Access Compliance Report Public Rights-of-Way (Curb Ramps)

Main Street: SIENNA_PKWY		Cross Street: S_SELLAS_RD		Location:	NE
ADA ID: RPRK211111133323	Ramp Type: Type 1 - Perpendicular	Initial Pass/Fail: Fail	Overall Compliance: No	Severity Score:	16

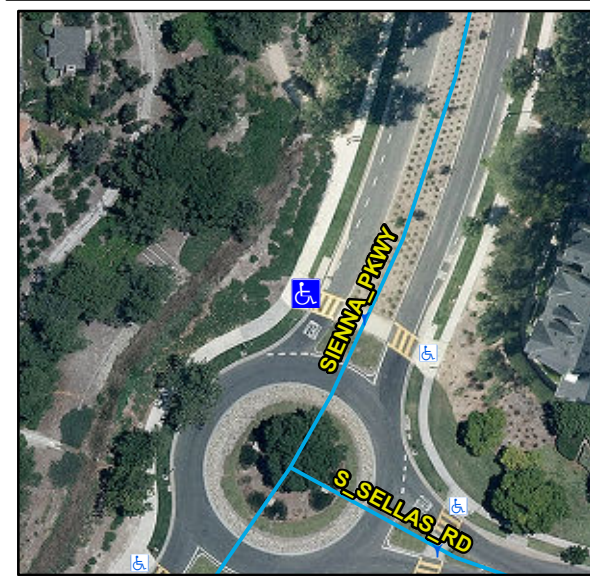
R304.2.2, R204.3, R304.5.3, STD 1115

Compliance	Description	Data	Compliance	Description	Data
N/A	Ramp Length (in)	91	N/A	Flare Type LT	
Yes	Ramp Width (in)	48			N/A
No	Ramp Run Slope (%)	8.4	N/A	Flare Slope LT (%)	N/A
No	Ramp Cross Slope (%)	2.3	N/A	Flare Traversable LT	N/A
N/A	Landing Present	N/A	N/A	Flare Type RT	
N/A	Landing Length (in)	N/A			N/A
N/A	Landing Width (in)	N/A	N/A	Flare Slope RT (%)	N/A
N/A	Landing Run Slope (%)	N/A	N/A	Flare Traversable RT	N/A
N/A	Landing Cross Slope (%)	N/A	N/A	DWS Provided	N/A
N/A	Landing Movement Obstructed?	N/A	N/A	DWS Contrast	N/A
	Landing Movement Type	N/A	N/A	DWS Length (in)	N/A
N/A	Landing Shared	N/A	N/A	DWS Full Width	N/A
N/A	Clear Space	N/A	N/A	DWS Offset Left (in)	N/A
N/A	Clear Space To Crosswalk (in)	N/A	N/A	DWS Offset Right (in)	N/A
N/A	Marked Crosswalk 1	Yes	N/A	Marked Crosswalk 2	N/A
	Crossing 1 Direction	SE		Crossing 2 Direction	N/A
	Marked Crosswalk 1 Width (in)	144		Marked Crosswalk 2 Width (in)	N/A

N/A	Ramp Inside Crosswalk 1	Yes	Yes	Ramp Inside Crosswalk 2	N/A
	Crossing 1 Slope (%)	0.2		Crossing 2 Slope (%)	N/A
	Crossing 1 Cross Slope (%)	3.5		Crossing 2 Cross Slope (%)	N/A
N/A	Gutter Ponding	N/A	No	Curb Slope	7.8
Yes	Gutter Lip Height (in)	0		Road Run Slope (%)	N/A
N/A	Gutter Run Slope (%)	N/A		Road Cross Slope (%)	N/A
N/A	Gutter Cross Slope (%)	N/A			
Yes	Overall Surface Condition: Acceptable		No	Perp Joint Present	No
	Cross Gutter Present?	No		Spandrel Present?	No
	Replace Cross Gutter?	N/A		Replace Spandrel?	N/A

Remove & Replace Entire Ramp.
